ARCHITECT'S SUPPLEMENTAL INSTRUCTIONS

PROJECT:	Residence at Heritage West New Development Andover, KS	Report No.	Nine (9)
OWNER:	OPG Heritage West Partners, LLC Dan Maximuk 234 N. Santa Fe Ave, Suite A Salina, KS 67401	Date	October 17, 2025
CONTRACTOR:	MCP Build 3501 SW Fairlawn Rd., Suite 100 Topeka, KS 66614	Architect's Proj No.	24-3379
		Contract For:	General Construction Mechanical, Electrical

REVISION:
ASI 9-10-17-2025

A ROOF PLAN
3/32"=1'-0"

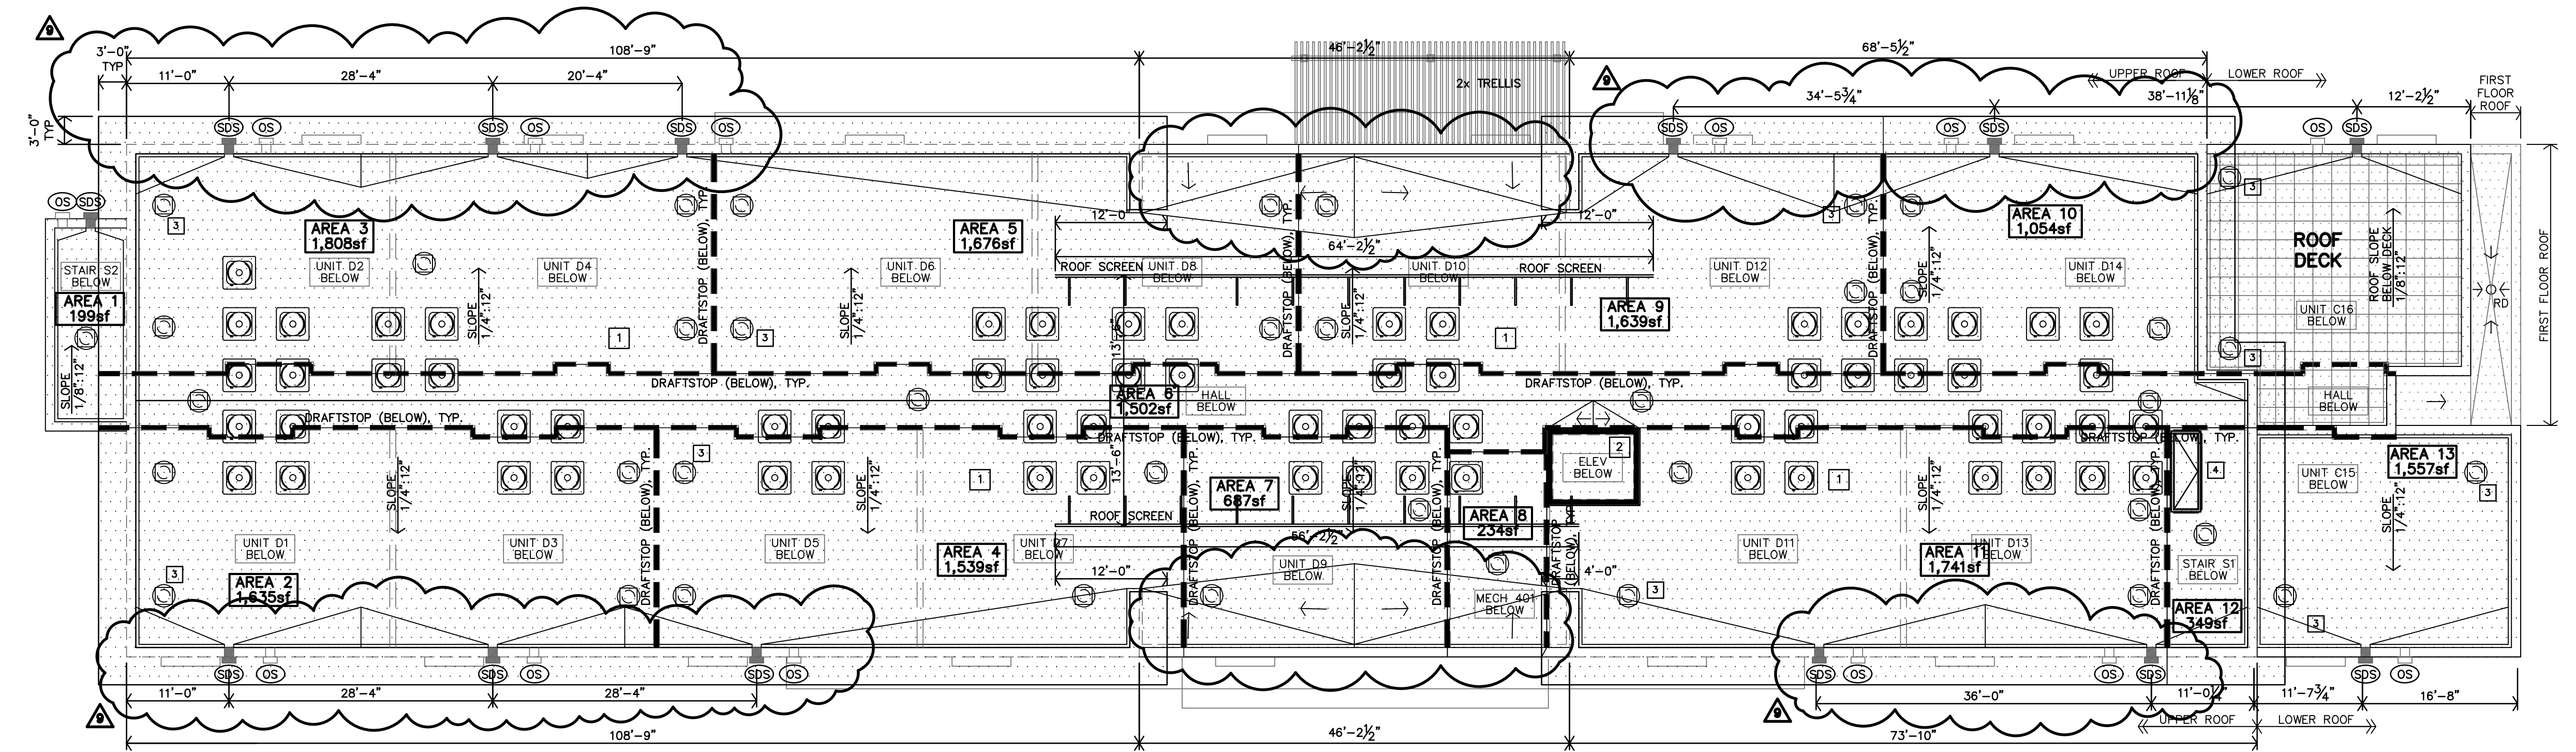
The roof drain/downspout scuppers, and overflow drains have been relocated along the parapet to avoid any downspout vertical leader lines from conflicting with the lower exterior wall overhangs. New dimensions have been added to the roof plan A5.1 showing those drain locations. Per notes on A5.1, all overflow drains shall be located a minimum of 2" above the main roof drain scuppers, along the parapet as shown. Prefer greater than 2" difference away.
